CITY OF LAVON Agenda Brief

MEETING: September 22, 2026

ITEM: 5 – H

Discussion and action regarding the site plan and landscape plan for a 181,372 square foot Walmart retail store and fueling station on 20.803 acres on Lot 7, Block A of the preliminary plat of the Heritage Square project at 840 S. SH 78, southeast of the intersection of SH 78 and SH 205, southwest of the intersection of SH 78 and Grand Heritage Blvd., and northeast of the intersection of SH 205 and Endeavour, City of Lavon, Collin County, Texas (CCAD Property ID 2624070).

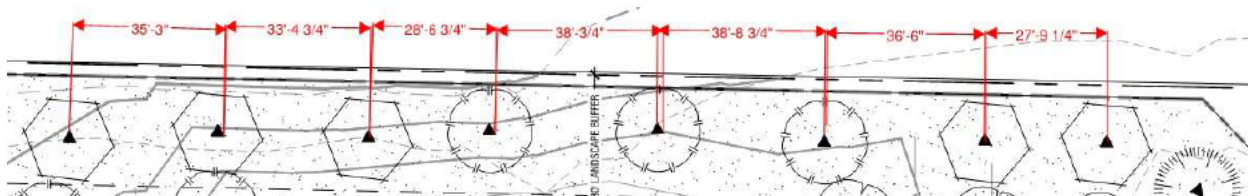
10. One large tree is required per 25 linear feet along SH 78. Revise the Landscape Plan to reduce the distance between the trees along SH78, as required by the PD.

KH Response: Landscape plan has been revised to provide a tree every 25' along SH 78.

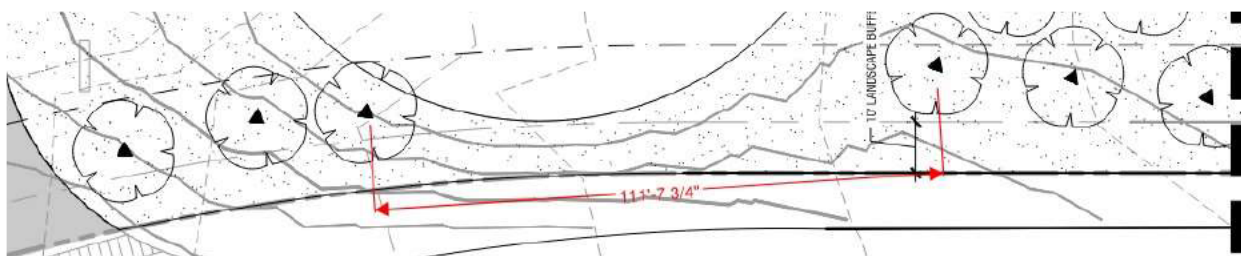
11. One large tree per 30 linear feet of buffer is required along public streets. The frontage along Grand Heritage Boulevard is compliant, but the frontage along Endeavor Boulevard has a gap of approximately 111 feet where no street trees are proposed in the buffer. Revise the Landscape Plan to increase the number of trees provided along the section of landscaped buffer along Endeavour Boulevard shown below, as required by the PD.

KH Response: Landscape plan has been revised to provide a tree every 30 LF along Endeavor Boulevard.

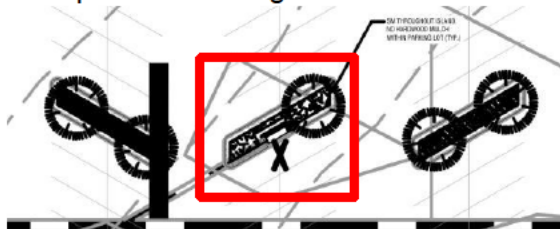
12. The parking lot tree requirement in Subarea A calls for one tree/parking island per 15 parking spaces. Revise the Landscape Plan to add additional trees in the parking lot landscape islands, where only one tree is proposed, to meet this requirement as required by the PD. Example area needing an additional tree:

KH Response: Landscape plan revised to show one tree per every 15 parking spaces.

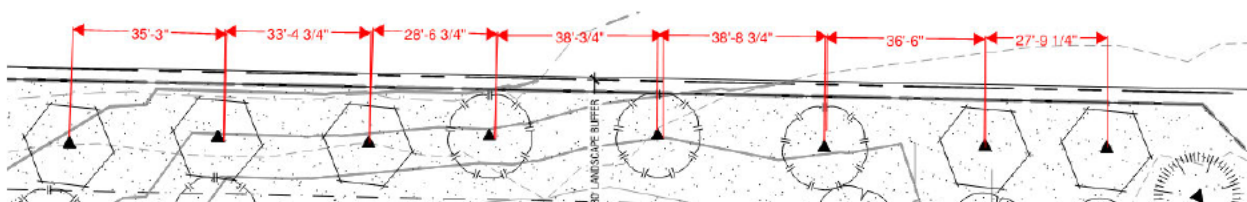
8. The area near the pharmacy is striped instead of landscaped, but this area should provide additional landscaping, terminus trees, etc. in coordination with applicable landscaping standards.

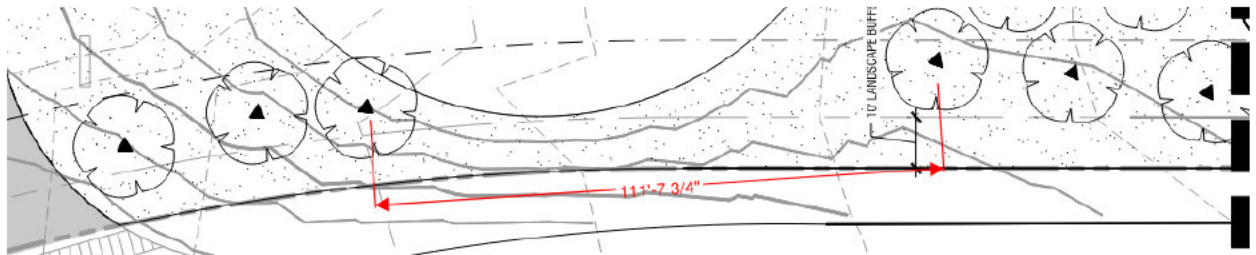
9. Please confirm no drone field/area is proposed on the site.
10. One large tree is required per 25 linear feet along SH 78. Revise the Landscape Plan to reduce the distance between the trees along SH78, as required by the PD.

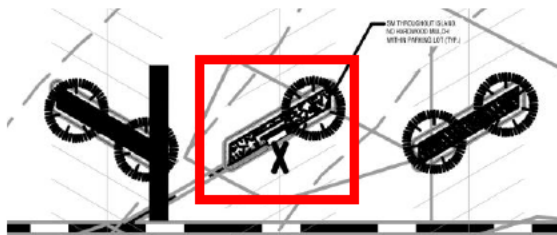
11. One large tree per 30 linear feet of buffer is required along public streets. The frontage along Grand Heritage Boulevard is compliant, but the frontage along Endeavor Boulevard has a gap of approximately 111 feet where no street trees are proposed in the buffer. Revise the Landscape Plan to increase the number of trees provided along the section of landscaped buffer along Endeavour Boulevard shown below, as required by the PD.

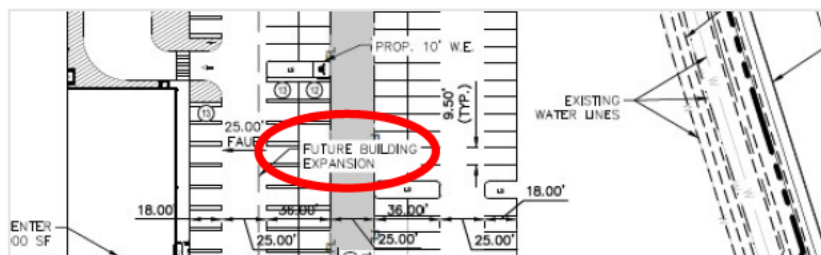
3. Clarify which radii are being referred to in the Site Note shown below.

Response: All radii that are not labeled on the site plan are either 2' or 10'.

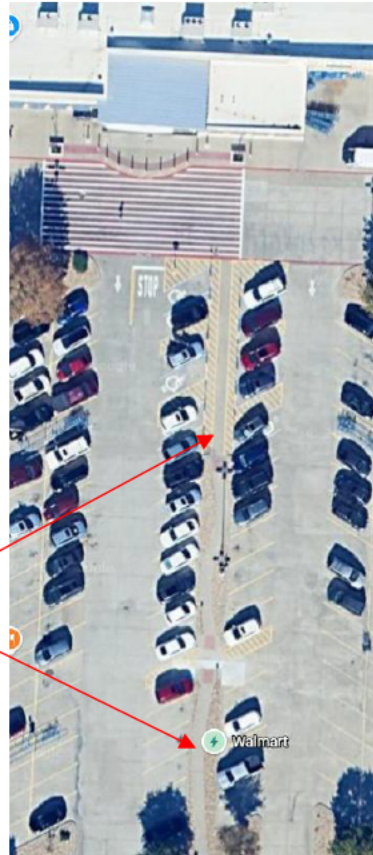
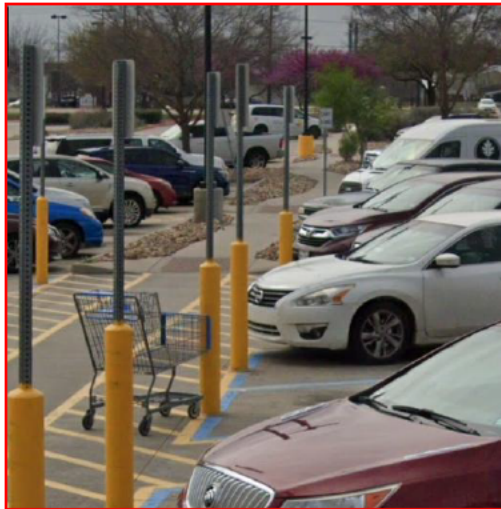
4. There is an indication of a Future Building Expansion on the Site Plan. Future site improvements will be reviewed, as a separate Site Plan submittal, at the time the modifications are ready to be developed. Revise the Site Plan to remove line work and notes related to the Future Building Expansion or provide the ultimate site layout with the building expansion included.

Response: Acknowledged, any future expansion will require a new site plan submittal. Future expansion callout and linework has been removed.

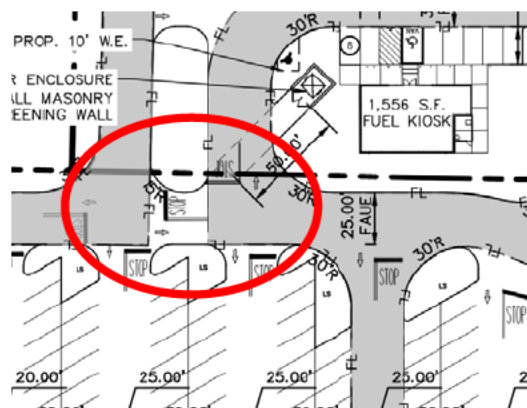
5. The Site Plan indicates that 751 parking spaces are provided on the Walmart retail site. Our review indicated a count of 744 spaces. Revise the Site Plan to correct the Site Data Summary Table to list the correct number of parking spaces provided.
6. Parking areas are required to include pedestrian amenities, such as sidewalks and pedestrian ways, perpendicular to the main building. Revise the Site Plan to include a sidewalk or pedestrian pathway through the parking areas that allow for north-south pedestrian travel. Other Walmart example below:

Response: A 5' sidewalk has been added to the middle of the parking field leading up to the fuel station.

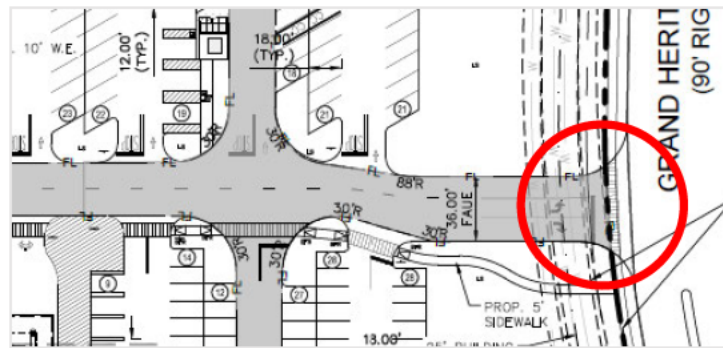
7. Revise the Site and Landscape Plans to connect the fire lane, at the point identified below, to provide continuous cross-access.

Response: Fire lane has been revised to have continuous cross access.

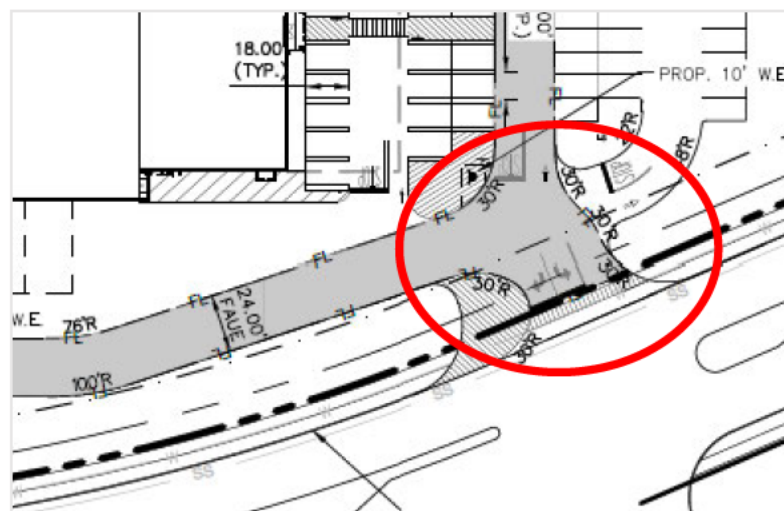
8. The southern driveway access, from the site to Grand Heritage Boulevard, does not have turning radii labeled. A minimum turning radius of 30 feet is required. Revise the Site Plan to ensure the turning radius is at least 30 feet and labeled at this location.

Response: These turning radii are 30'. Radii labels have been added to the site plan

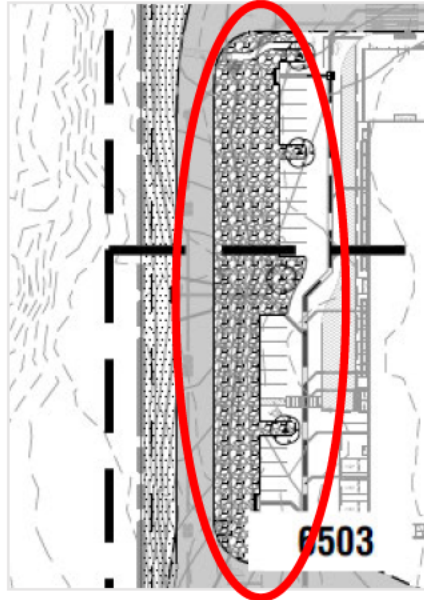
13. Revise the Landscape Plan to label and dimension the landscape buffers.
14. 75% of any landscape area is required to be vegetative matter. There are various landscape areas that do not appear to meet this requirement (example shown below). Revise the Landscape Plan to provide planting in these areas.

Response: Landscape plans have been revised so that all landscape areas are at least 75% vegetative.

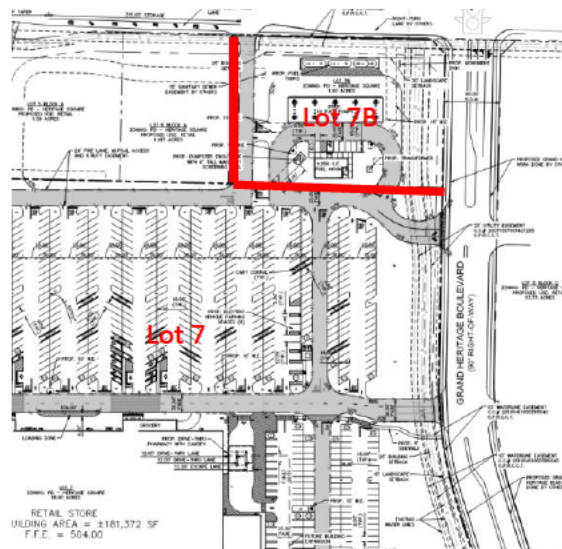
15. The Landscape Requirements Table references the City of Lavon Landscape Requirements but does not incorporate the landscape requirements from the PD. The Table also indicates items as “Provided”, such as four-inch caliper trees, that are not provided and vary from the specifications of the PD. Revise the Landscape Requirements Table to incorporate the applicable PD standards for landscaping and revise the required and provided columns to correspond to the standards accordingly.

Response: Trees have been revised to be 4" caliper. PD standards have been added to the Landscape Requirements Table

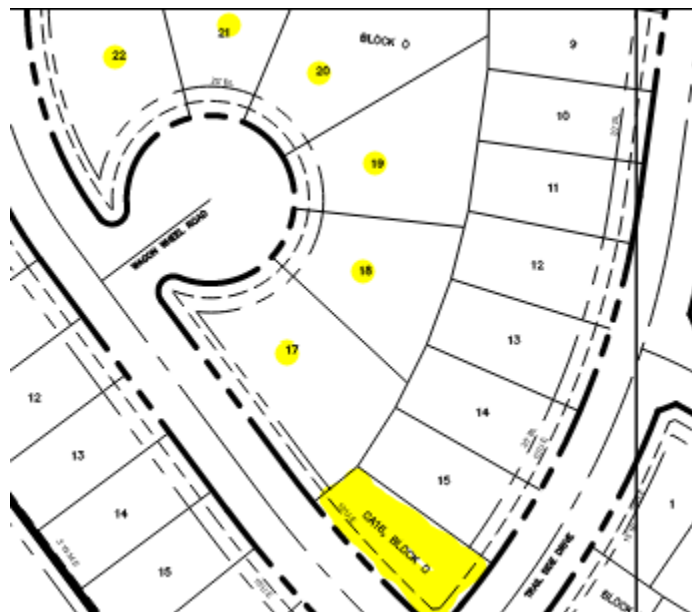
2. Revise the Final Plat to split Block L at the common area at CA20, Block L (in between currently labeled Lots 20 and 21), creating two separate blocks. Alternatively, Lot 14, Block L could be relabeled to Block 20, Block L and the rest of the lots could be relabeled accordingly.

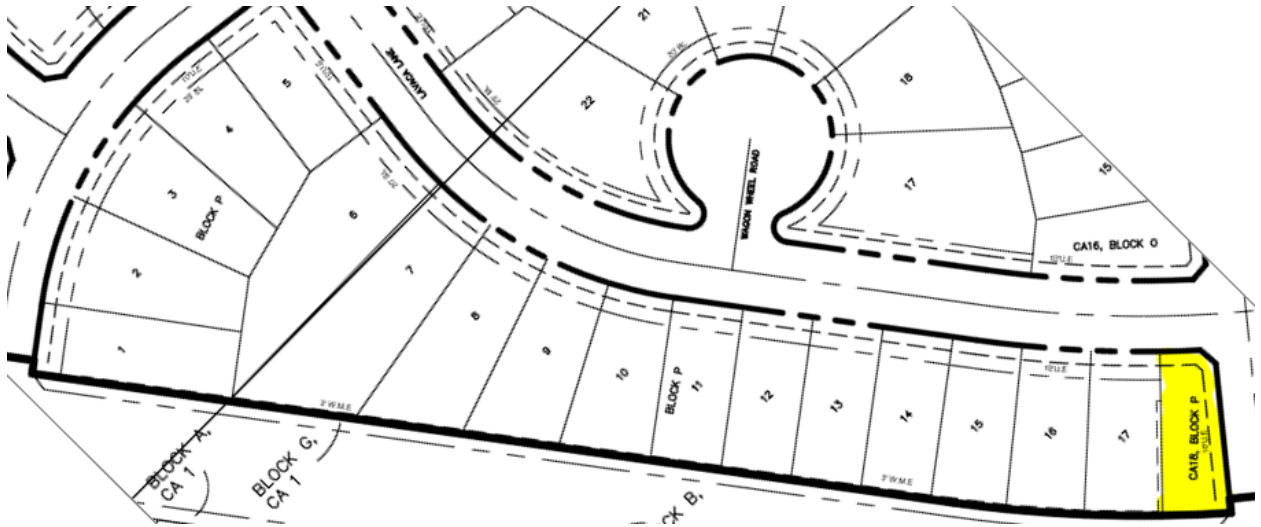
3. Revise the Final Plat to relabel CA16, Block O to CA1, Block O. Relabel the remaining lots in Block O accordingly.
